UNITED STATES NUCLEAR REGULATORY COMMISSION REGION II 101 MARIETTA STREET, N.W. ATLANTA, CEORGIA 30323

Report Nos.: 50-369/92-07 and 50-370/92-07

Facility Name: McGuire 1 and 2

Inspection Conducted: February 24 - 27 and April 6, 1992

#### Reactivity Worth

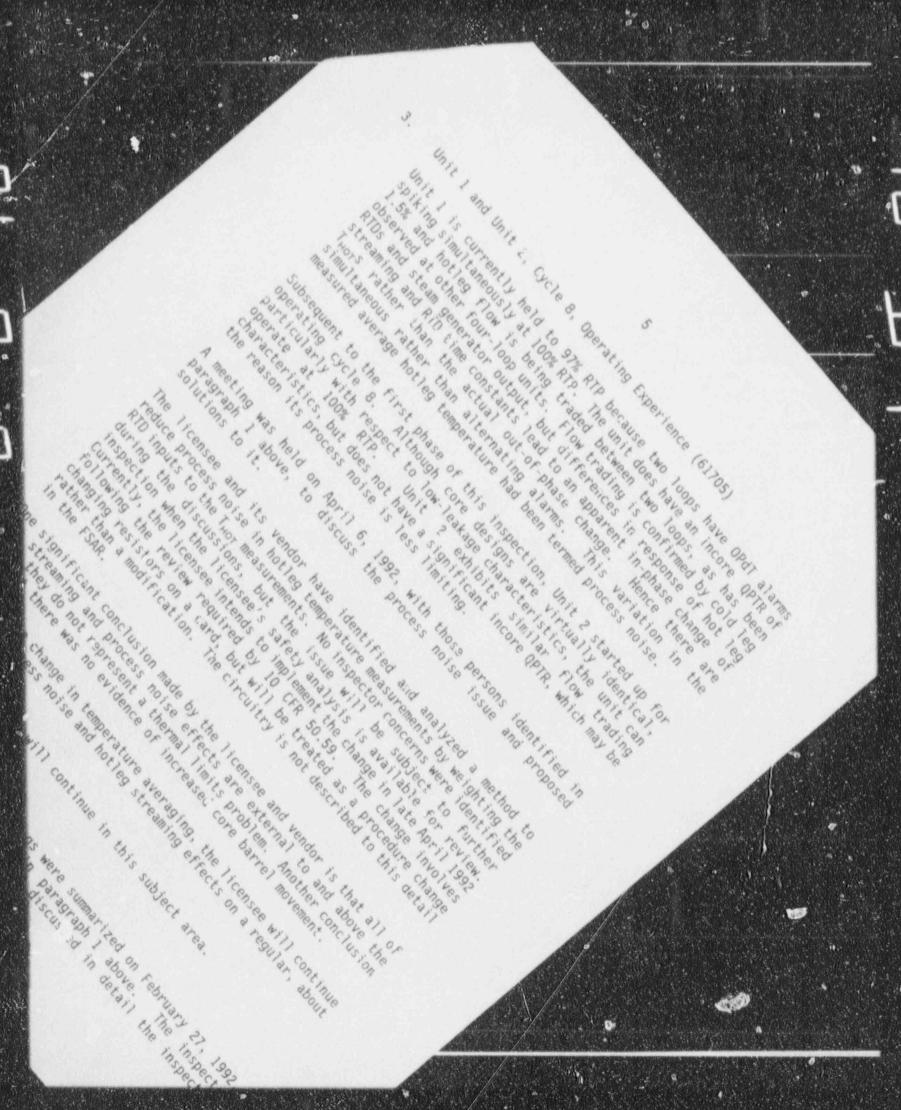
The acceptance criterion for the reference bank worth measurement was  $\pm 15\%$  of the predicted worth and the acceptance criterion for the worth of each control rod bank measured by rod swap was the larger of  $\pm 30\%$  of prediction or  $\pm 200$  pcm of prediction. A final criterion was that the sum of all rod worths be  $\geq 90\%$  of prediction. Since all other measurements are dependent upon the precision of the reference bank measurement, these acceptance criteria do not appear consistent with the assumption used in SDM calculations that rod worth is known to  $\pm 10\%$ . As shown above, the actual test results satisfy a more rigorous acceptance criterion. The licensee is reviewing the acceptance criteria for these measurements in that light. The licensee's review will be tracked under IFI 50-369 and 50-370/92-07-02: Determine appropriate acceptance criteria for control rod worth measurements consistent with SDM calculations.

- IFI 50-369 and 50-370/92-07-01: Assure procedural controls are adequate to prevent over dilution of the VCT (paragraph 2.a).
- IFI 50-369 and 50-370/92-07-02: Determine appropriate acceptance criteria for control rod worth measurements consistent with SDM calculations (paragraph 2.c).
- 5. Acronyms and Initialisms
